**DATE:** 03.20.2015  
**TO:** ProTrak  
**FROM:** Bill McDow  
Transportation Planning

■ **RIVERLIGHTS CONVENTIONAL NEIGHBORHOOD PHASE 1 [SRB Plan Review]**

🌀 Initial Review Note 🌀

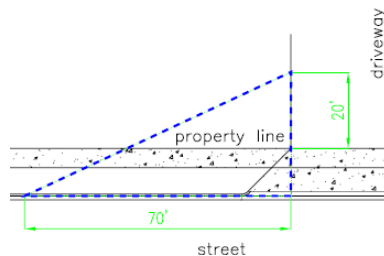
- ❖ The Riverlights Development Agreement and TIA required a three lane cross section with a least 300' of internal storage, (Driveway 3B) for this access point. However, the site plans show approximately 100' of internal storage.
- ❖ Maintain the Taper for the left turn lane at the Old Towne Street and River Road intersection.
